Additional Information

Clonbrone, Esker Hill, Lucan, Co. Dublin

AI Submission

Ref No. SD22A/0390

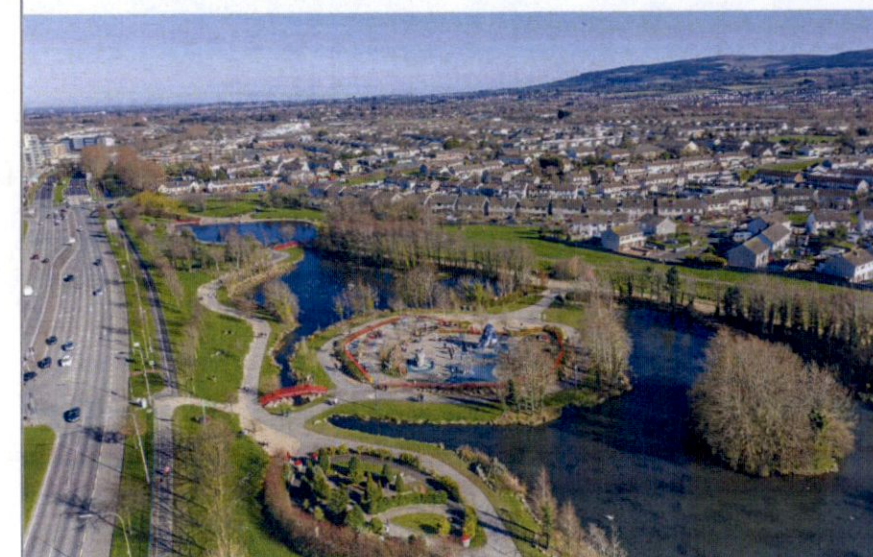
- **Green Space Factor not correctly applied.** *The Green Space factor has not been applied correctly. For example, the arborists report shows one tree being protected whose canopy lies partly within the site, yet a proposed surface area of 695m² is shown for preserved trees. We believe if applied correctly the Green Space Factor would fail.*

We have reviewed the previous form submitted and noticed an anomaly in our figures that has been corrected for this submission. The green space factor has been correctly applied now in the following pages.

- We have proposed a greater amount of trees to be planted than being removed. The green space factor has been applied at 2 stages.

1. Initial score @.375
2. After 2 years when trees are considered existing. After 2 years the green space factor shall .5
